## 10.4 Other Features of Steam and Power Conversion

The information in this section of the reference ABWR DCD, including all subsections, tables, and figures is incorporated by reference with the following departures and supplements.

Figure 10.4-6 Feedwater System

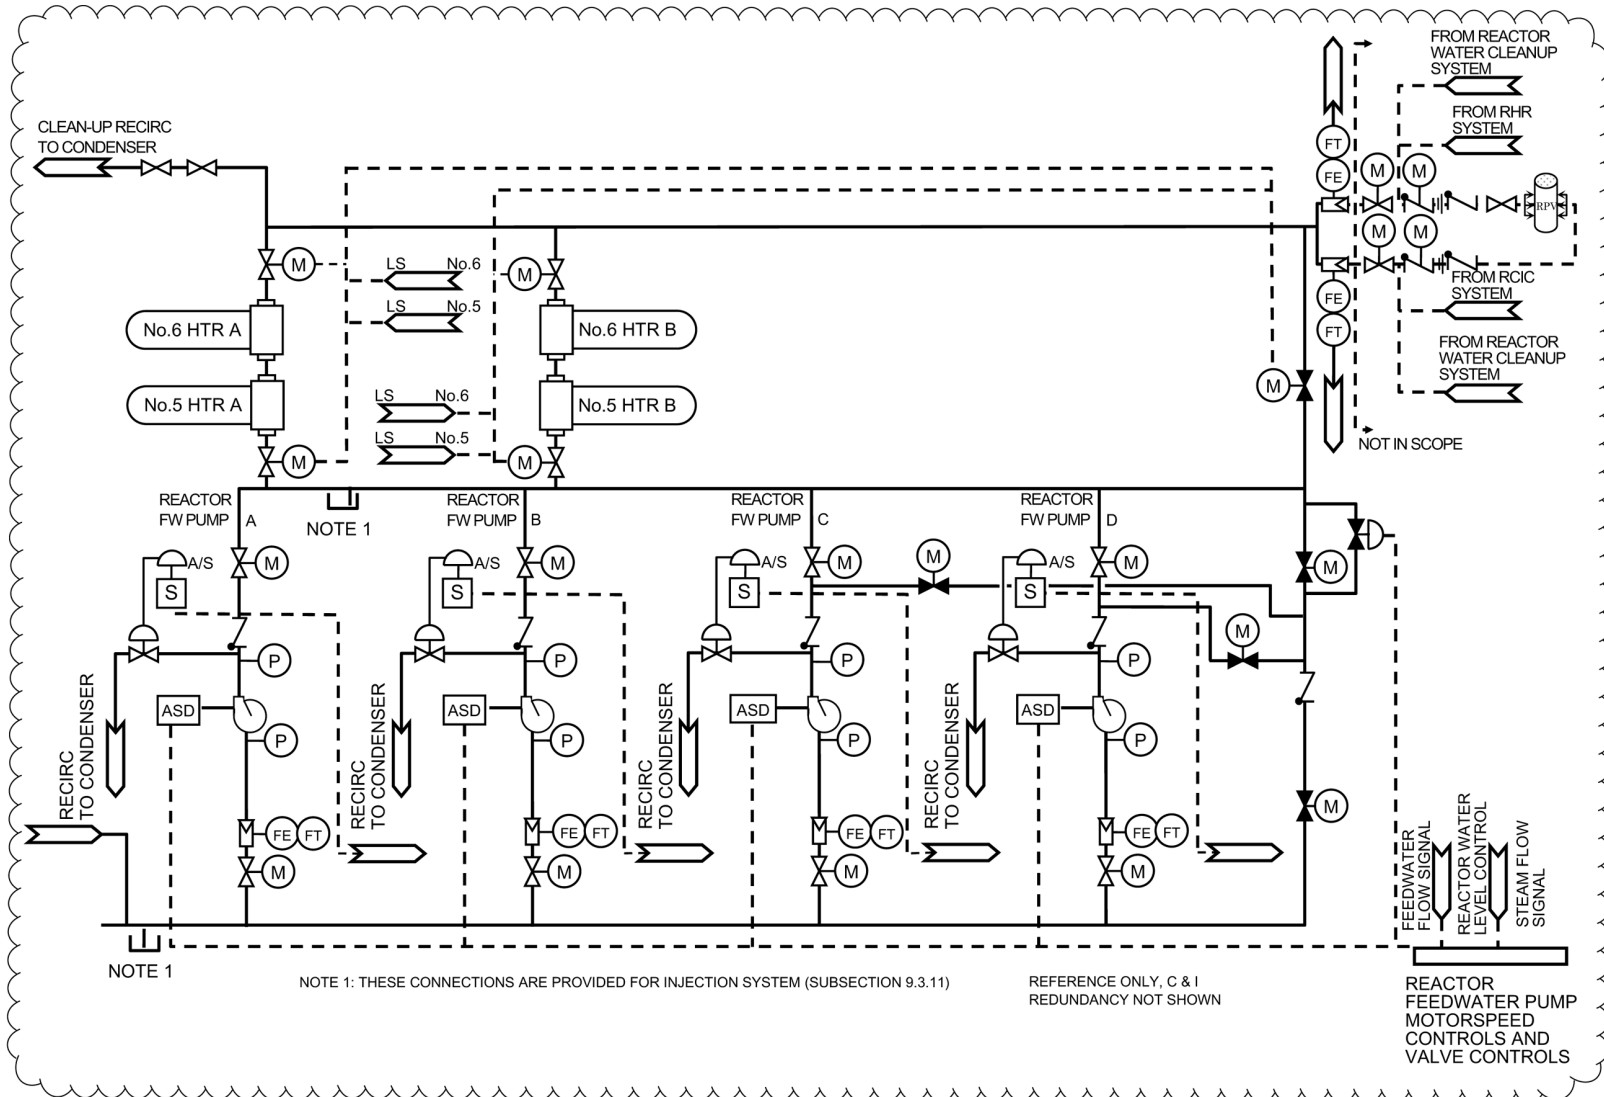
STD DEP 10.4-5 (Tables 10.4-4, 10.4-5 and 10.4-6, Figures 10.4-5, 10.4-6, 10.4-7, and 10.4-8)

*The Condensate and Feedwater System (Figures 10.4-5 and 10.4-6) consists of the piping, valves, pumps, heat exchangers, controls and instrumentation, and the associated equipment and subsystems which supply the reactor with heated feedwater in a closed steam cycle utilizing regenerative feedwater heating. The system described in this subsection extends from the main condenser outlet to (but not including) the seismic interface restraint outside of containment. The remainder of the system, extending from the restraint to the reactor, is described in Chapter 5. Turbine cycle steam is utilized for a total of six stages of closed feedwater heating. The drains from each stage of the low-pressure feedwater heaters are cascaded through successively lower pressure feedwater heaters except the lowest and second lowest pressure feedwater heaters which drain to the low pressure heater drain tanks for each string. The drains from each low pressure heater drain tank flow into the external drain coolers of each lowest pressure feedwater heater and finally to the main condenser. The high pressure heater drains are pumped backward to the reactor feedwater pumps suction. The cycle extraction steam, drains and vents systems are illustrated in Figures 10.4-7 and 10.4-8.*

Figure 10.4-9 Bypass Valve Control, Electro-Hydraulic Control Unit

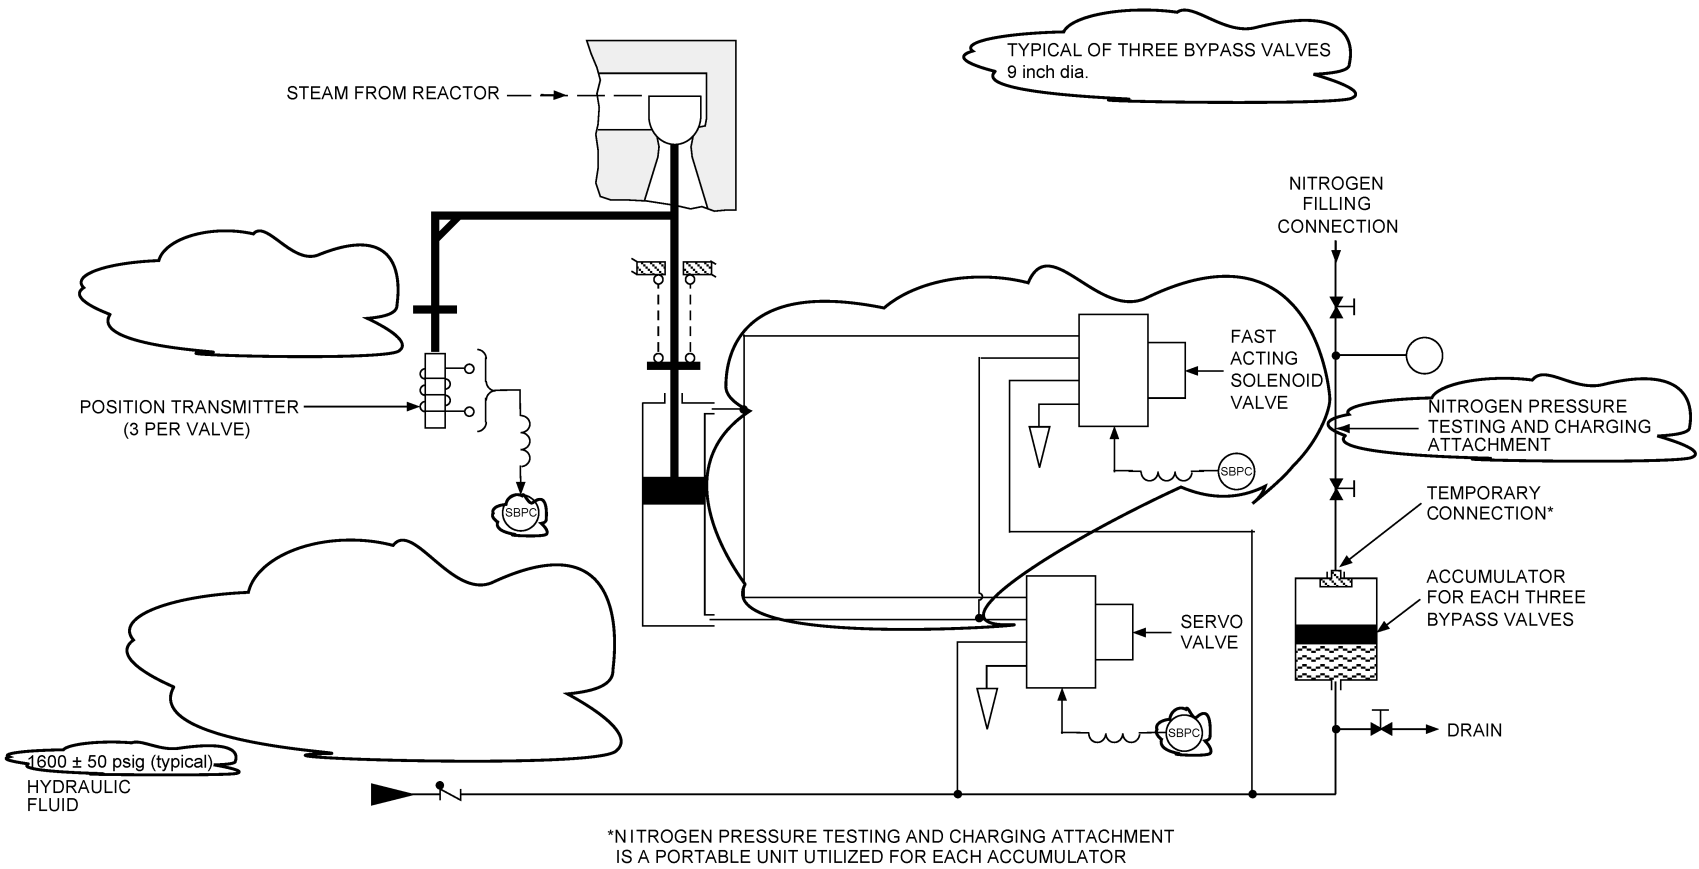
STD DEP 10.4-7 (Figure 10.4-9)
